Access Compliance Report

Public Rights-of-Way

(Curb Ramps)

Intersection ID: 50592	Main Street: BENDING_BRANCH_RD	Cross Street: BRISTLEY_RD	Location: NE
ADA ID: 73040F49C563	Ramp Type: Perp	Initial Pass/Fail: Pass	Overall Compliance: No
Codes/Mitigation Info/Possible Solution		Field Measurements/Component Compliance	
Severity Score: 5.25

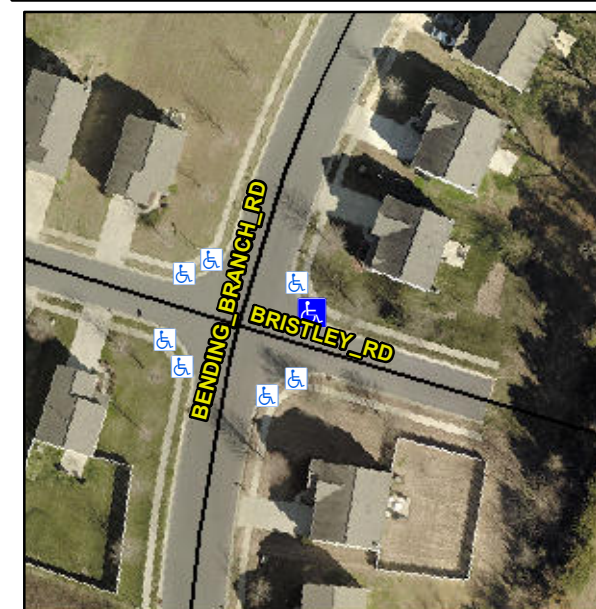
**Not Found, R304.5.3, R305.2,
R304.5.4**

Compliance	Description	Data	Compliance	Description	Data
N/A	Ramp Length (in)	48.0	Yes	Ramp Slope (%)	6.1
Yes	Ramp Width (in)	48.0	No	Ramp XSlope (%)	4.3
N/A	Flare Type LT	Sloped	N/A	Flare Type RT	N/A
N/A	Flare Slope LT (%)	0.0	N/A	Flare Slope RT (%)	11.3
N/A	Flare Traversable LT?	No	N/A	Flare Traversable RT?	No
Yes	Landing Length (in)	48.0	Yes	DWS Provided?	Yes
Yes	Landing Width (in)	79.0	Yes	DWS Contrast?	Yes
Yes	Landing Slope (%)	0.9	Yes	DWS Length (in)	24.5
No	Landing X Slope (%)	4.8	Yes	DWS Full Width?	Yes
N/A	Landing Curb? (Y/N)	No	No	DWS Offset (in)	6.5
N/A	Shared Landing?	Yes			
Yes	Gutter Ponding?	No	No	Gutter Slope (%)	10.5
Yes	Gutter Lip Ht (in)	0.0	No	Gutter X Slope (%)	4.9
N/A	Painted X Walk1?	No	N/A	Painted X Walk2?	N/A
	X Walk 1 Direction	To S		X Walk 2 Direction	N/A
N/A	X Walk 1 Width (in)	N/A	N/A	X Walk 2 Width (in)	N/A
	X Walk 1 Slope (%)	2.3		X Walk 2 Slope (%)	N/A
	X Walk 1 X Slope (%)	3.1		X Walk 2 X Slope (%)	N/A

**Remove & Replace Entire Ramp.
Remove & Replace Gutter.**
